SPARC® Enterprise M8000/M9000 Servers Product Notes

For XCP version 1060

SPARC Enterprise M8000/M9000 Servers Product Notes 1

FIGURE 1-18 SPARC Enterprise M8000 Server + Power Cabinet Bottom View

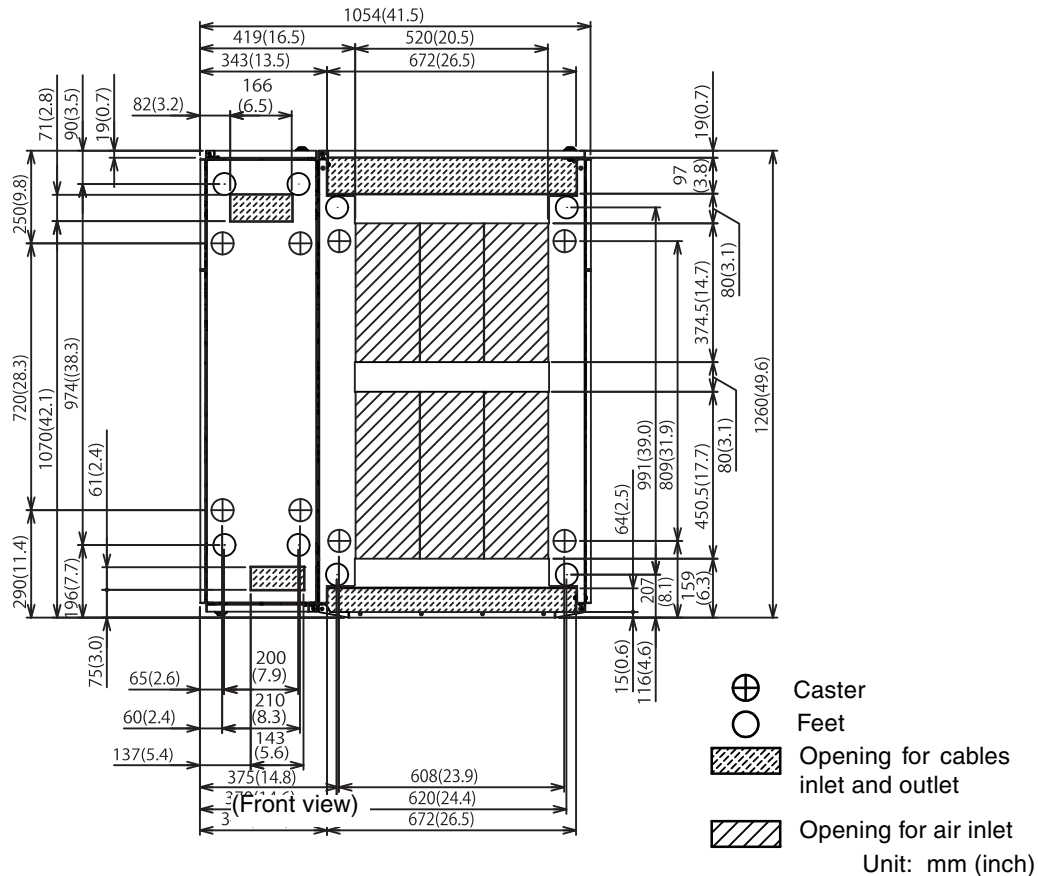
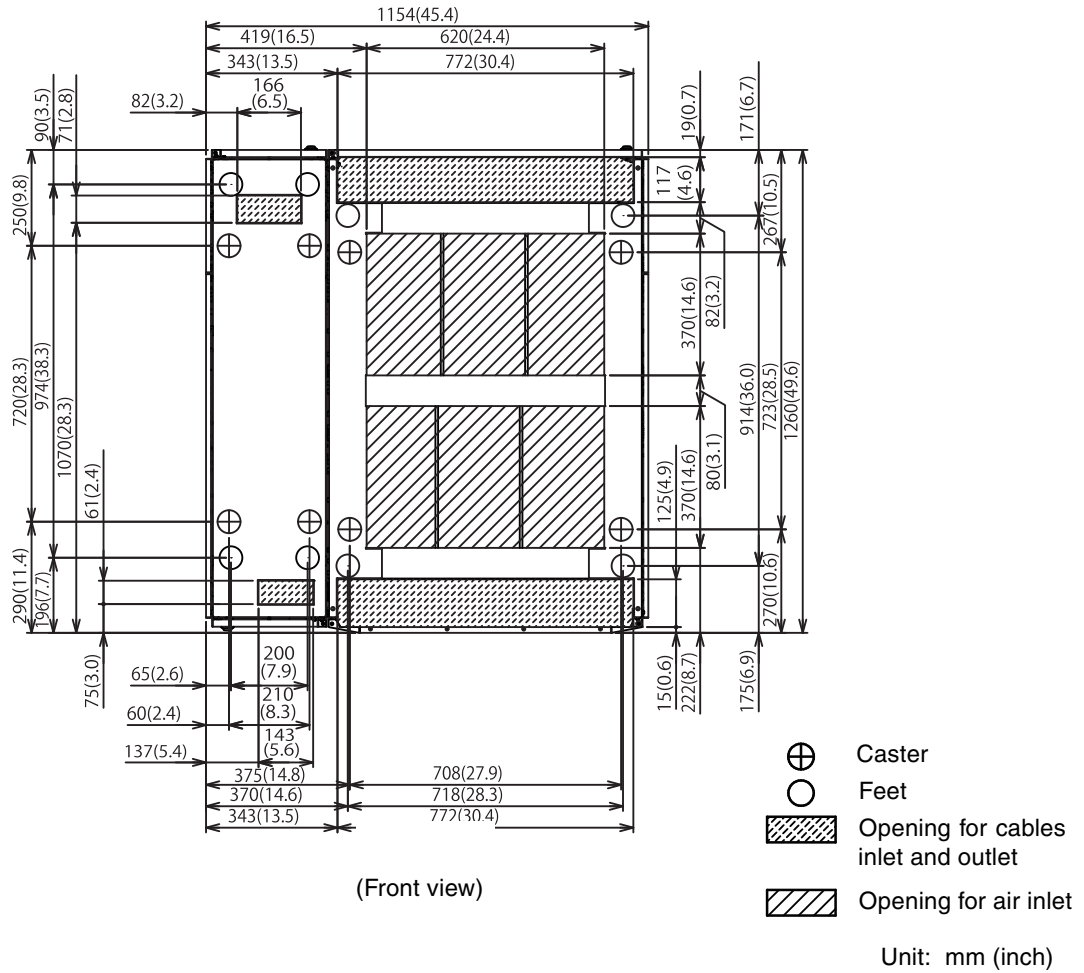
This is to correct the description in Section 1.2.2.2, "Bottom View of the Components", FIGURE 1-18 SPARC Enterprise M8000 Server + Power Cabinet Bottom View and FIGURE 1-20 SPARC Enterprise M9000 Server (Base Cabinet) + Power Cabinet Bottom View. The correct figures are as follows:
